**PLANNING DIRECTOR'S SPECIAL PERMIT  
FOR SINGLE FAMILY RESIDENTIAL IN A PUD**

**FILE:** P02-043

**PROJECT NAME:** Creekside Village 2 (The Meadows)

Exhibit 6: Plan 2 (a)  
Elevations

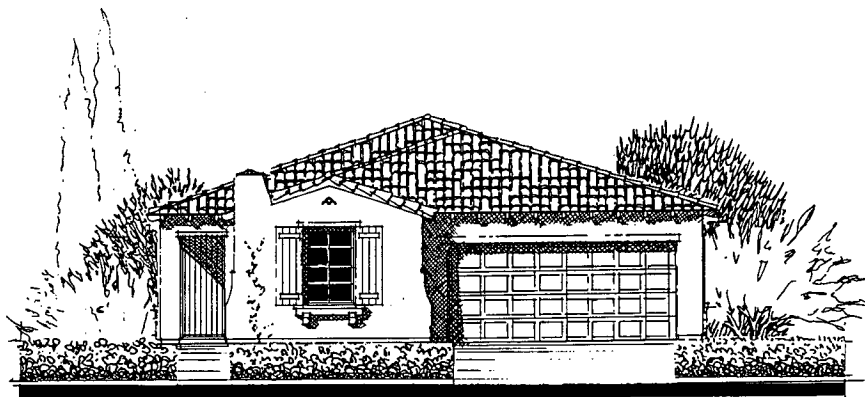
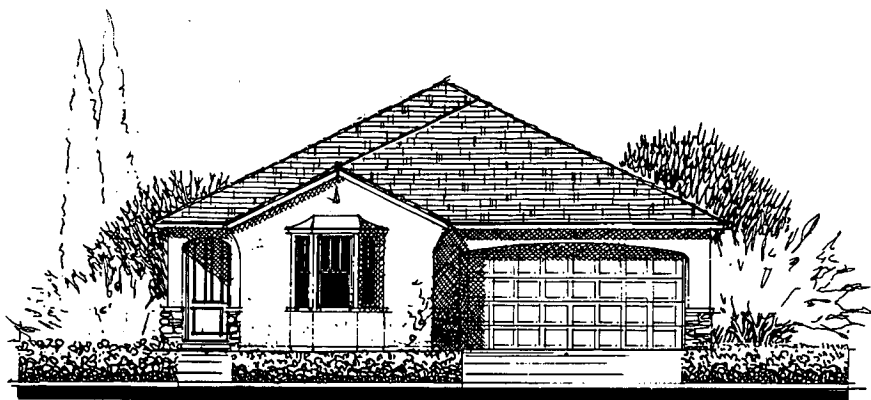
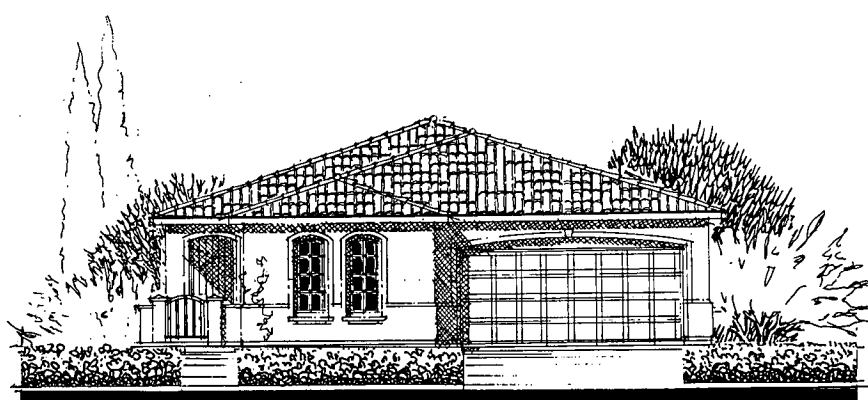
In order to mitigate the concern that the front entry on **Plan 1** and **Plan 2** is excessively recessed into a deep courtyard, the applicant will provide a 11 foot deep covered entry in **Plan 1** and an optional gated courtyard in **Plan 2** that serves as the main entry to the house. Staff recommend that optional courtyard should be available for all elevation of Plan 2. As conditioned, the project represents a high level of adherence to the City's Single Family Residential Design Principles.

- d. The Bay window in **Plan 2** shall not encroach into the 12.5 feet Public Utility Easement;
  - e. No porch should encroach into the required setback areas;

- m. Optional courtyard should be available for all elevations of **Plan 2**;
- n. Roofing shall be concrete tile; the roof shall be finished with end and ridge caps; and roof pitch shall be no less than a 4 to 12 pitch;
- o. A total of twelve color palette options shall be offered, four for each of the three elevations, as indicated on the color and materials board and schedule submitted with this application;

Exhibit 8: Plan 4 (a)  
Elevations

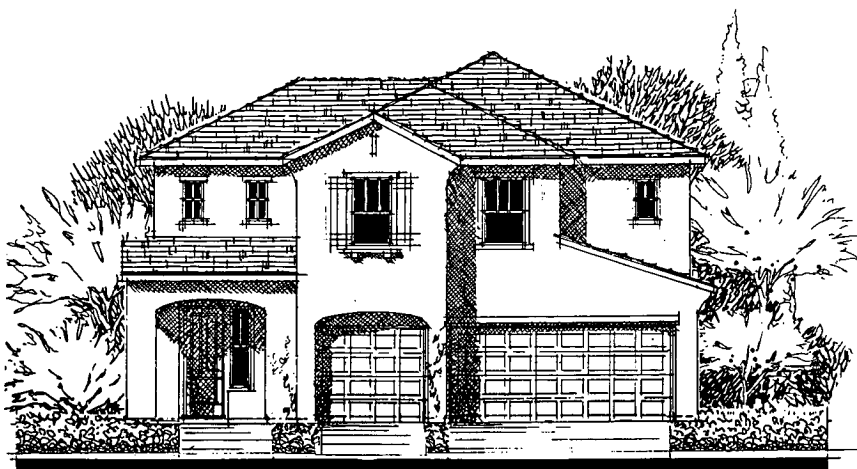
- g. For corner lots and irregular shaped lots, house plans should be located in the position that meet all setback requirements;
  - h. When **Plan 4** is constructed with a separate third-car garage or a workshop with garage door at the front of the house (instead of the 3<sup>rd</sup> Bay option), the minimum front setback of this garage or workshop must be 20 feet; however, with the Bay option, the minimum front setback of the house may be 12.5 feet;

- i. When **Plan 4** is sold with the separate third-car garage or workshop with driveway, landscape strips between the tire paths is required;
  - j. On corner lots, the driveway shall be located away from the intersection of streets;

Therefore, when **Plan 4** is sold with the separate third-car garage or workshop with driveway, landscape strips between the tire paths is needed.
